STUDER

Service Information

Hardware Modification Kit
40/88 for A820 MCH

SI 120b/88 E

Adjusting the lifter pin:

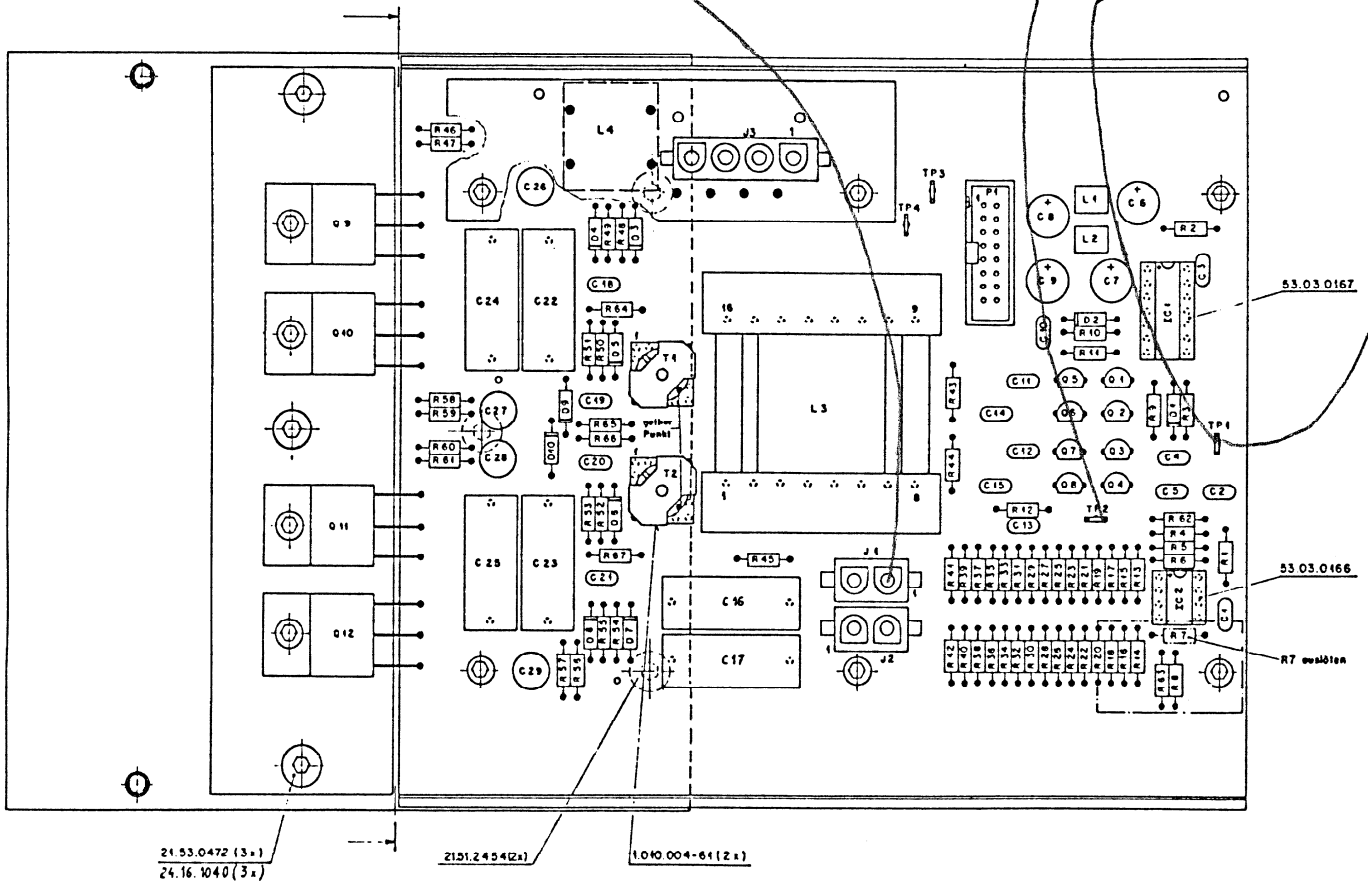
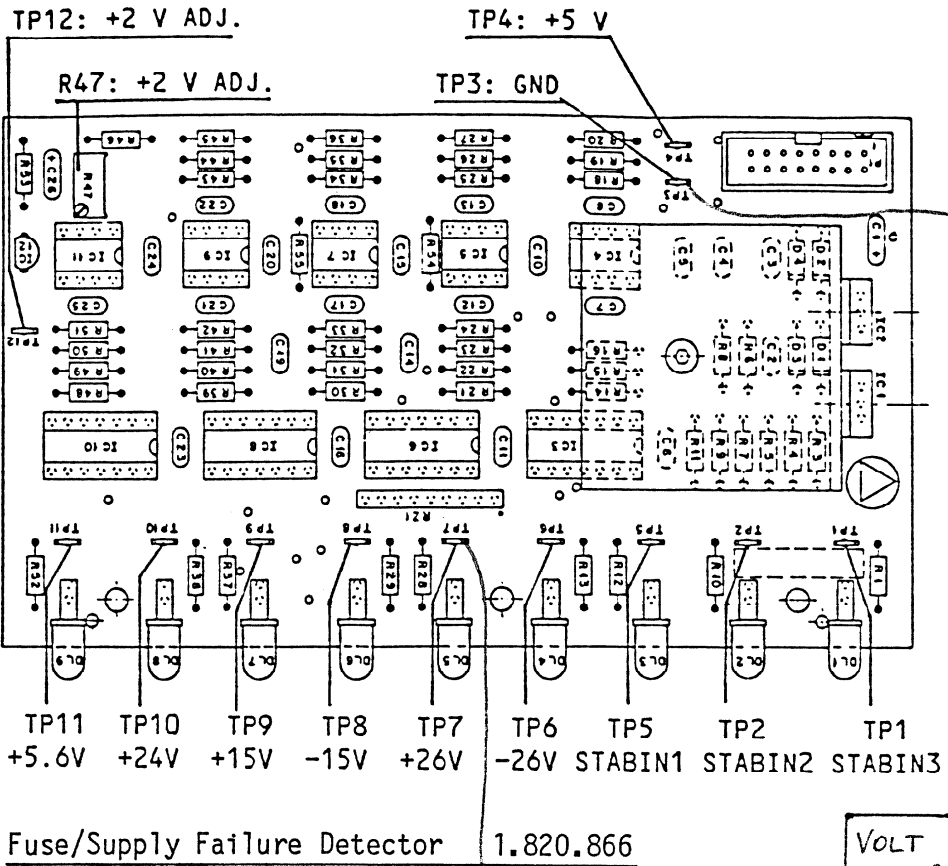
1. Load a tape.
2. Remove the headblock cover.
3. Switch recorder to EDIT. The tape must be separated from the capstan shaft by a few tenths of a millimeter. (the tape just does not touch the capstan shaft).
4. Should this not be the case, loosen the locknut (opening across flats 5,5 mm) and adjust screw (opening across flats 7 mm) to such a point where the tape just does not touch the capstan shaft in EDIT mode.
5. Retighten locknut.
6. Reinstall headblock cover.

Spooling Motor Drive Amplifier 1.820.875.81

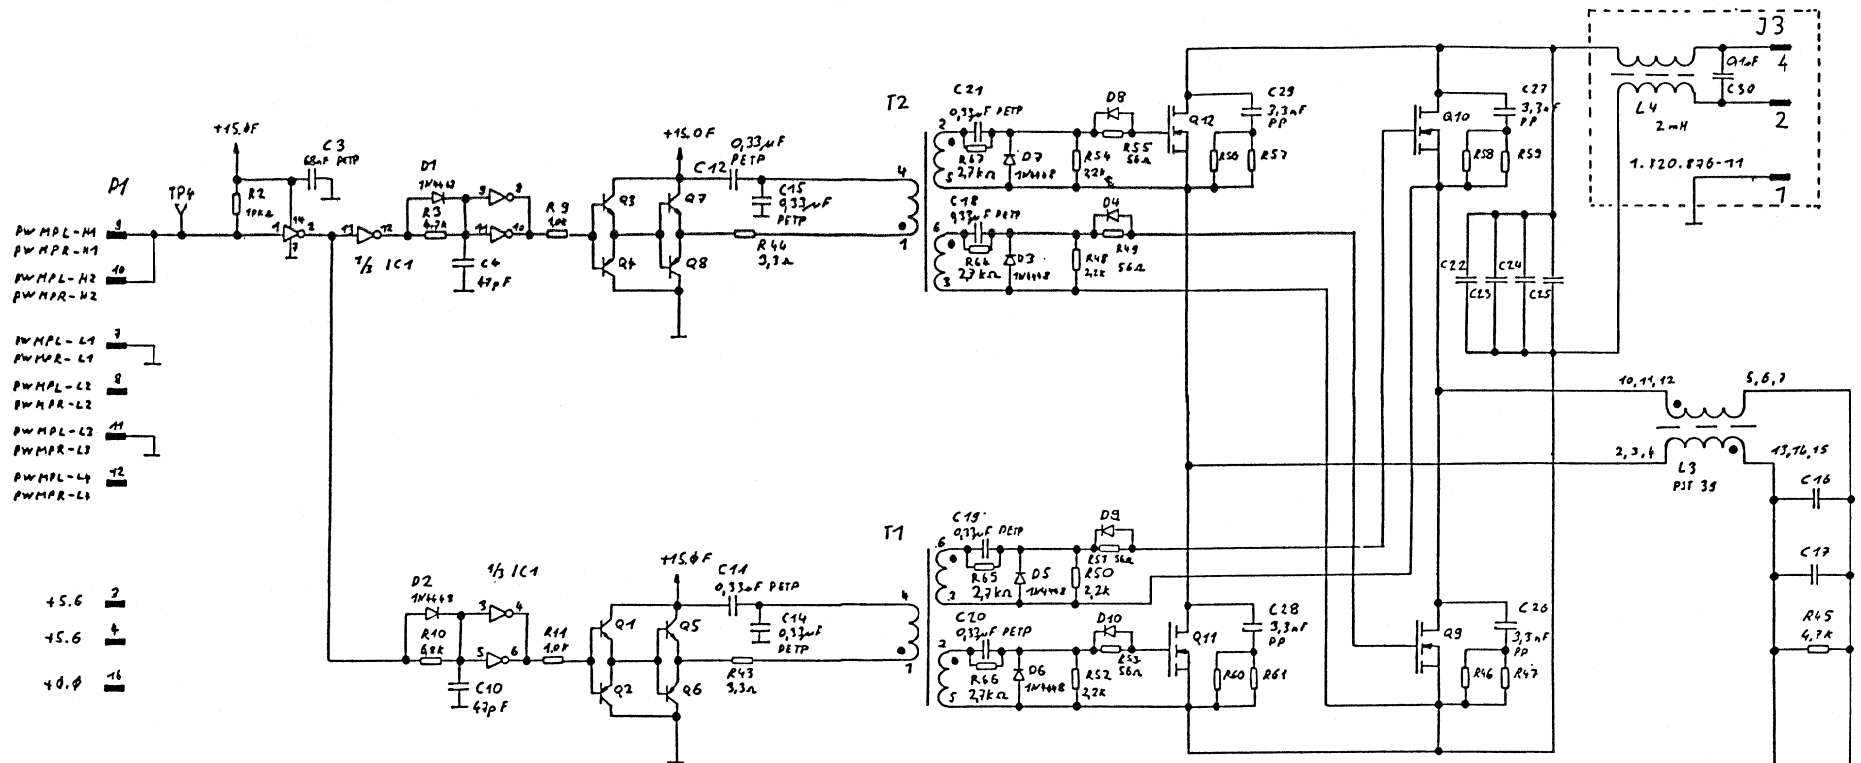
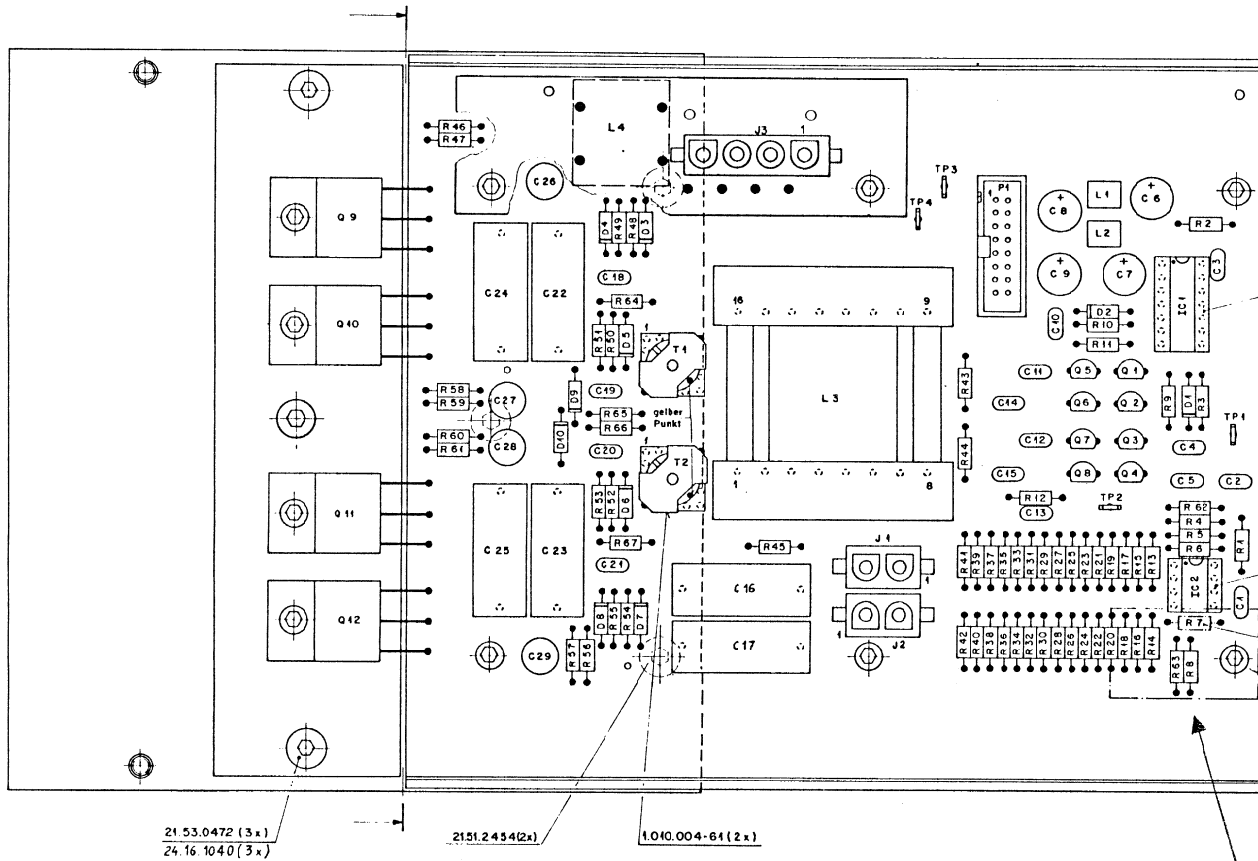
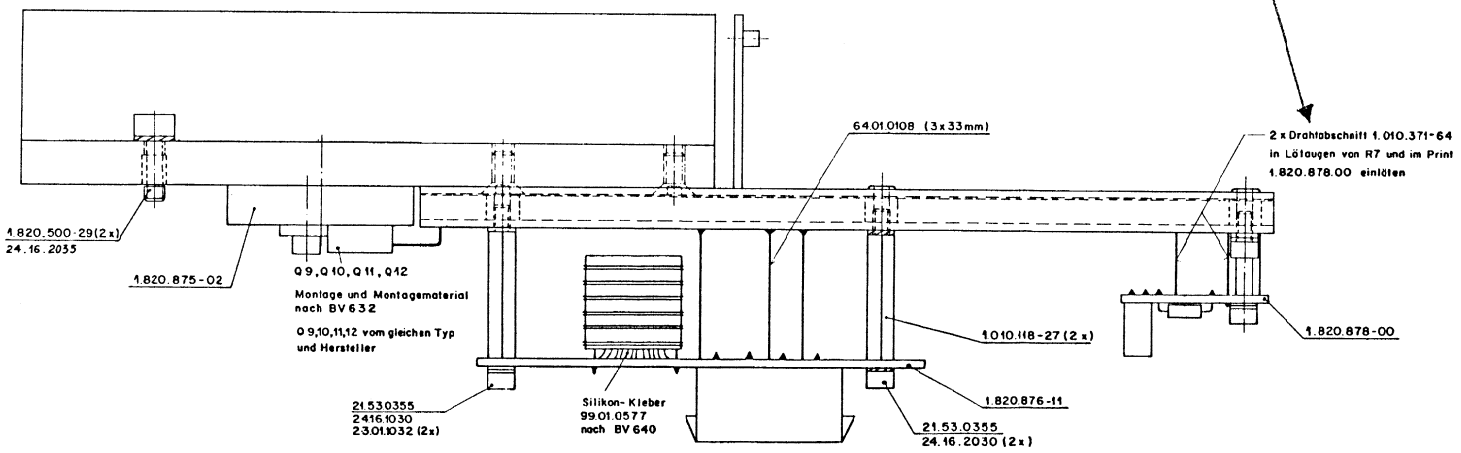
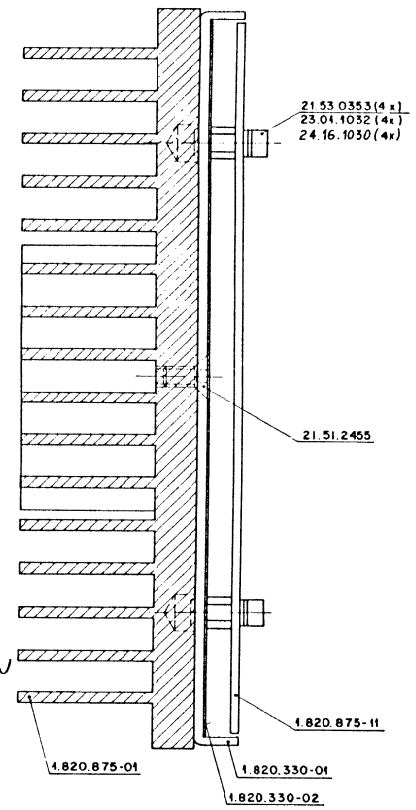
4. Modification instructions4.1 Spooling Motor Drive Amplifier 1.820.875.00Modification:

1. Remove resistor R7
2. Install Common Suppression Adjust Kit 1.820.878.00 :
(see Schematics and Layout)
 - 2.1. Remove screw and mount the 12 mm - bolt.
 - 2.2. Solder the two pieces of wire into the holes on the additional print 1.820.878.00.
 - 2.3. Screw the additional print 1.820.878.00 onto the previously mounted bolt.
 - 2.4. Solder the two pieces of wire into the holes of R7.
Check for good connection.
3. Attach label index .81 (1.010.081.43).

REMOVE R7
R7 auslöten

REMOVE SCREW
&
MOUNT THE
BOLT

Fig. 4.1. Common Mode Adjustment

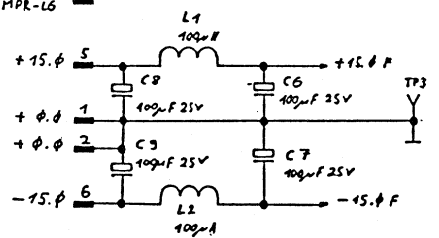
Common Mode Adjustment:

1. Connect only flat cable connector P1 to Spooling Motor Drive Amplifier. (All other connectors are unplugged.)
2. Switch tape recorder ON.
3. Measure offset voltage at TP2 (TP1 = ground) and write down offset voltage (voltage is between +/- 60 mV.)
4. Switch tape recorder OFF.
5. Apply a DC-voltage of +26 Volt to J1, Pin 1 with reference to TP1 (ground).
Use for this purpose the +26 Volt on TP7 (TP3 = ground) of the Fuse/Supply Failure Detector 1.820.866.00.
Make therefore the cable connections indicated in Fig. 4.1 .
6. Switch tape recorder ON.
7. Measure offset voltage at TP2 (TP1 = ground).
Adjust with potentiometer R101 (10kohm) to the same offset voltage as measured under step 3 (tolerance +/- 10mV).
8. Switch tape recorder OFF.
9. Secure potentiometer with locking-paint.
10. Repeat steps 1 - 9 for the second Spooling Motor Drive Amplifier.

POWER FAIL SENSE PCB 1.820.869.00

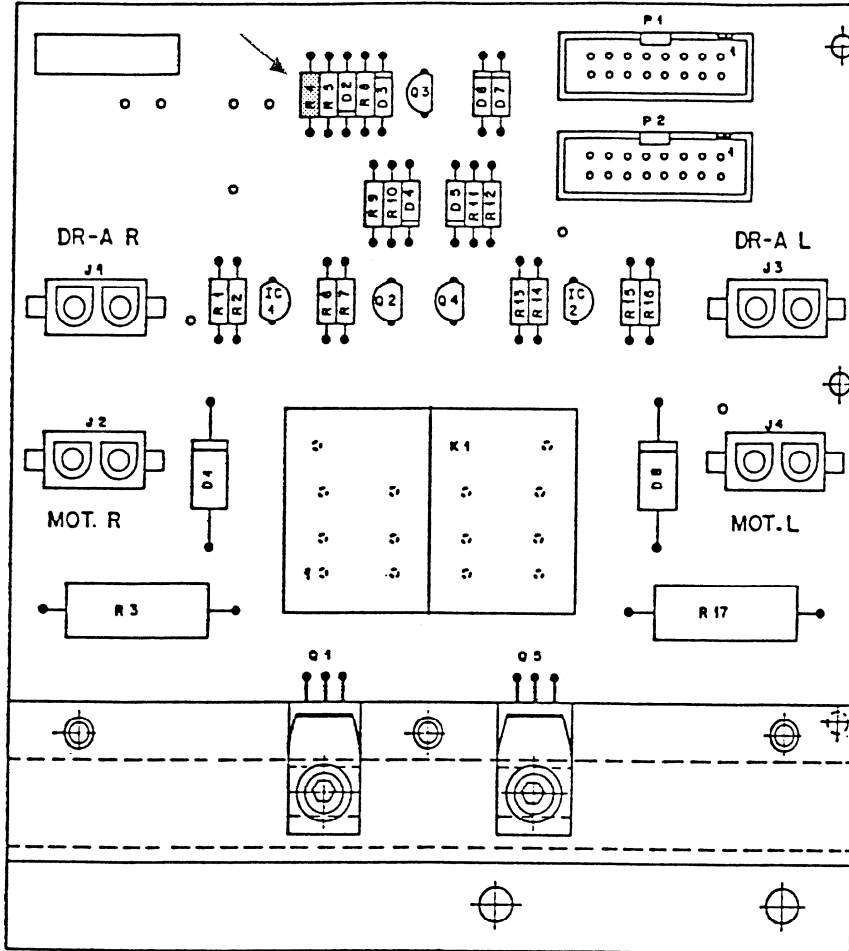
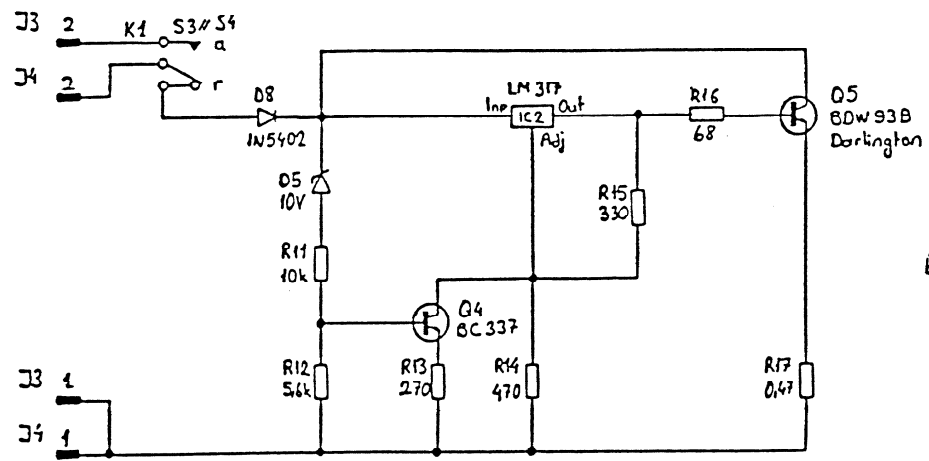
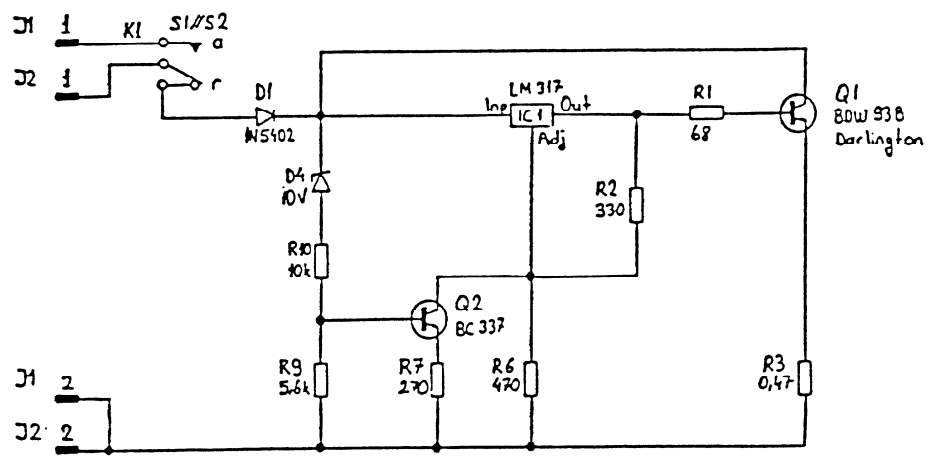
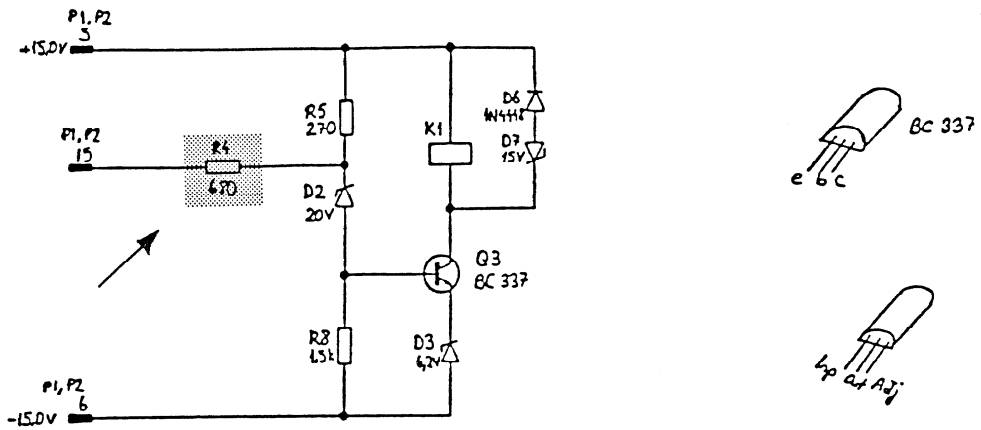
Due to a production error, resistor R4 is not inserted in the power fail sense board. (see attached schematics)

The resistor R4 must be inserted in all power fail sense boards in the existing A820 multi-track machines. The power fail sense board is located between the two spooling motors.

1. Tilt up the tape deck section for easy access.
2. Take out the Power Fail Sense Board 1.820.869.00.
(Layout 1.820.869.11)
3. Insert R4 680 Ohm (57.11.4681).
4. Put the Power Fail Sense Board back.

Fig. 4.2.

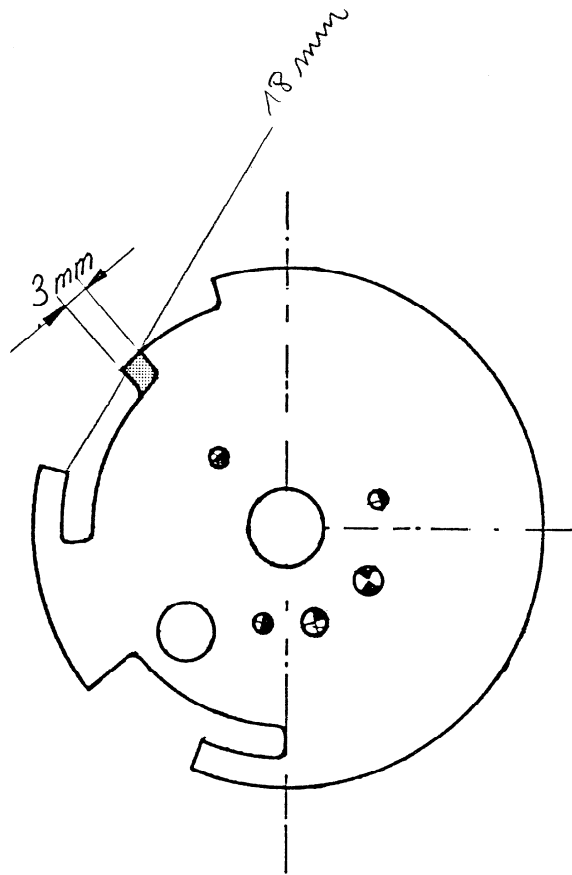
Insufficient stroke length of the pinch roller assembly may result in tape slippage.

The clearance of the pressure spring has to be increased to 0.5 ... 1mm.

1. Tilt up tape transport and remove right-hand Motor Assembly 1.820.141.00.
2. With a diagonal cutter or other suitable tool, shorten the right hand side control cam 1.820.141.06 by 3mm at the point indicated on the attached drawing. (Fig. X.X)
3. Motor assembly right 1.820.141.00 changes to 1.820.141.81. Attach index label .81 (1.010.081.43).

Fig. 4.3.

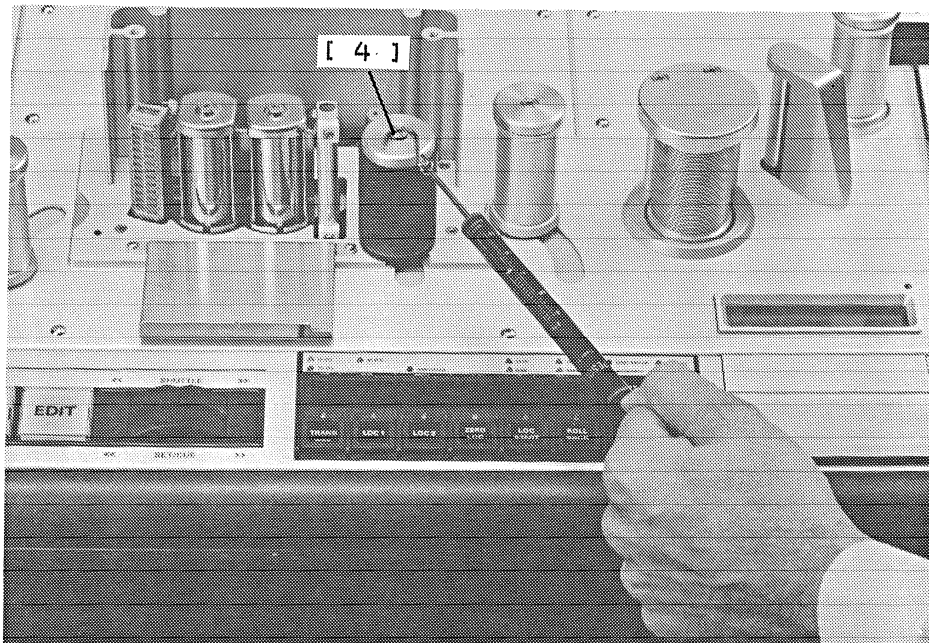
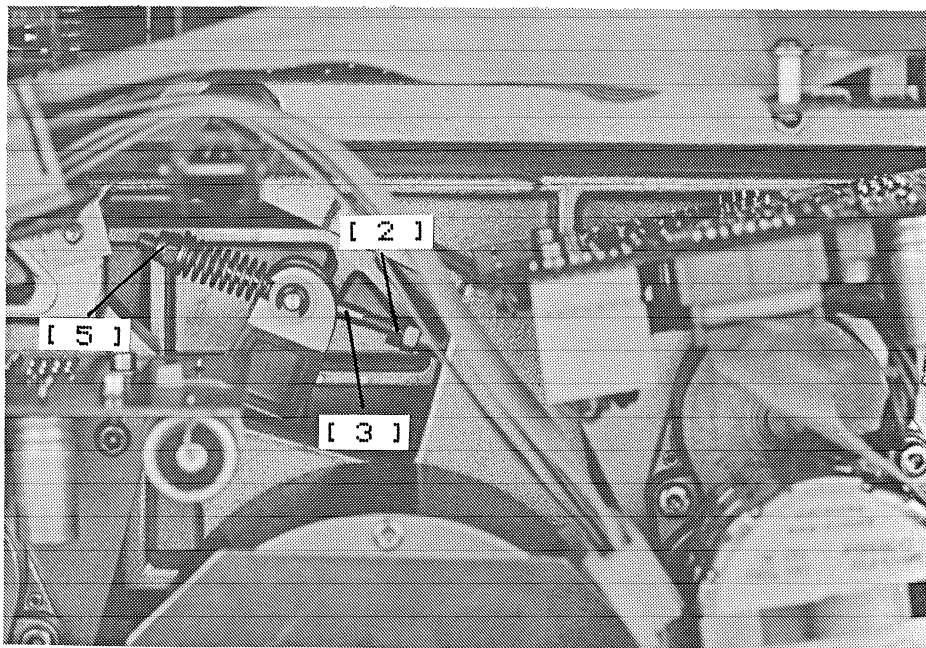
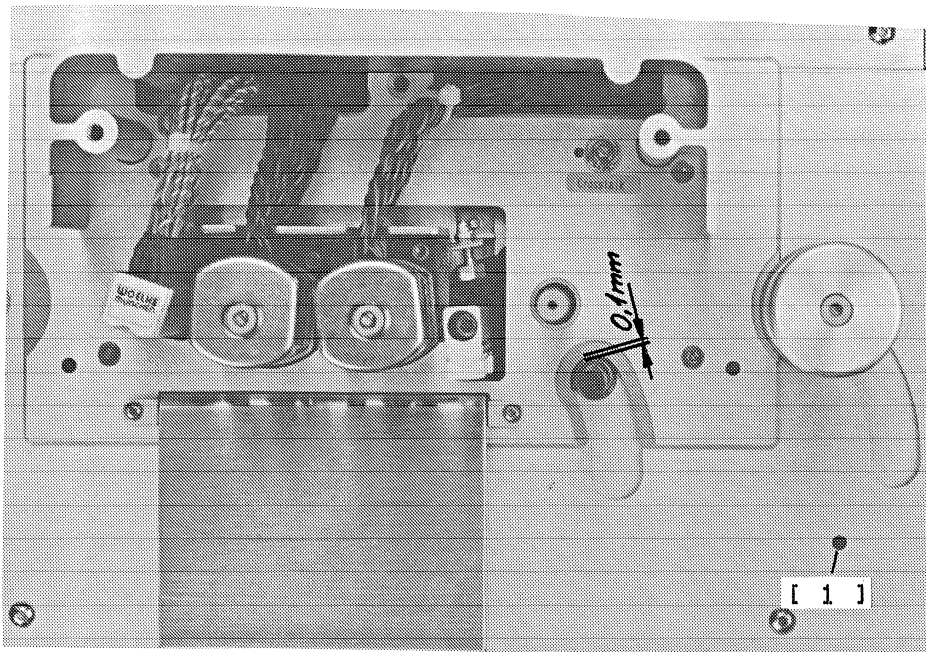
The modification necessitates a readjustment of the distance between the pinchroller shaft and the headblock plate.

Adjusting the distance between pinchroller shaft and headblock plate: (see Fig. 4.3)

1. Switch tape recorder OFF.
2. Remove pinch roller.
3. Insert allen key (3mm) into the hole [1] and turn the pinch roller assembly clockwise to the end stop (Play - Position).
4. Loosen locknut (opening between flats 7mm) [2] on the tie rod at the pinch unit and turn tie rod [3] until a distance of ca. 0.1mm between pinchroller shaft and headblock plate is obtained.
5. Retighten locknut and secure with locking paint.
6. Install pinch roller.
